Office Action Summary

10/803,189

FARD, MIKE

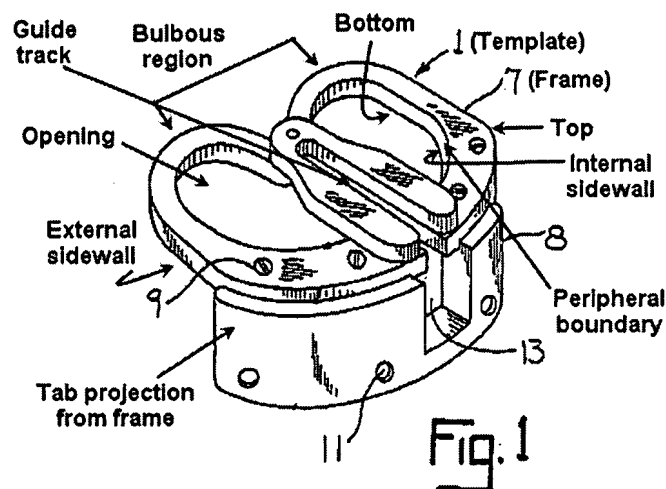
Dietz et al. (herein Dietz) discloses a template (1) comprising: a frame (7) having a top, a bottom, one or more external sidewalls, and one or more internal sidewalls (see Figure 1 below), said frame (7) having one or more openings extending there through from said top to said bottom wherein at least one of said one or more internal side walls defines a peripheral boundary of each of said one or more openings (see Figure 1 below; col. 2, lines 38-39); a guide track (15,18; see Figure 1 and 6 below) formed in said one or more internal sidewalls, said guide track (15,18) receiving a guide of a bone milling device (col. 2, lines 16-21) whereby said bone milling device may be moved about said peripheral boundary using said guide track (15,18; col. 2, lines 16-12 and 58-67; col. 3, lines 1-19). It is noted that Dietz explicitly discloses another embodiment where the template contains a track for guiding the bone milling device (see Figure 6

and 7 below). The template (1) further comprises a pre-bent fastening means means for removably securing said frame (7) to a posterior surface of a bone, which is to be milled (col. 2, lines 28-30).

The means for removably securing includes one or more tabs (pre-bent) projecting from said frame (7) which have one or more securing points which may be secured to a bone (col. 2, lines 28-36). One or more tabs project from said one or more external side walls (see Figure 1 below).

is capable of being used as claimed if one so desires to do so. The peripheral boundary has one or more bulbous regions (see Figure 1 below).

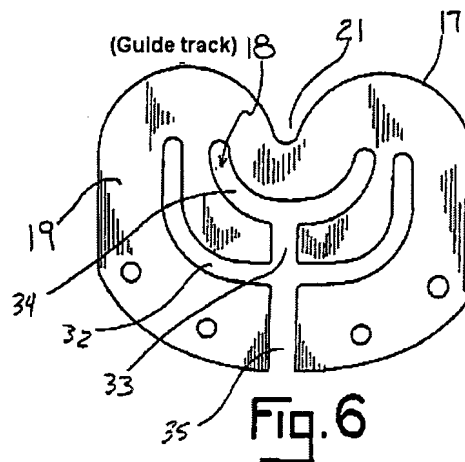
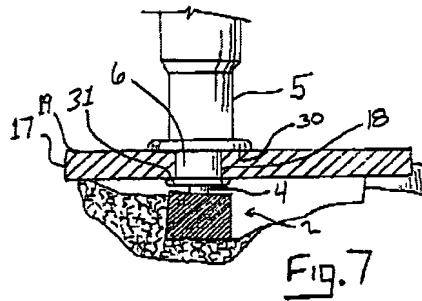
The guide track (15,18; see Figure 1 and 6 below) is positioned approximately midway between said top and said bottom of said frame (7). The guide track (15,18) has a flat lower surface, which is approximately parallel to said top and said bottom of said frame (col. 2, lines 39-61). The guide track (15,18) has an angled upper surface which projects at an angle from said lower surface to a point relatively closer to said top of said frame than said bottom of said frame (col. 2, lines 39-67 and col. 3, lines 1-19). The guide track (15,18) has an arcuate upper surface, which extends from said lower surface to a point relatively closer to said top of said frame than said bottom of said frame (col. 2, lines 65-67 and col. 3, lines 1-19). The guide track (15,18) has an arcuate lower surface and an angled upper surface which projects at an angle from said lower surface to a point relatively closer to said top of said frame than said bottom of said frame (col. 2, lines 65-67 and col. 3, lines 1-19).
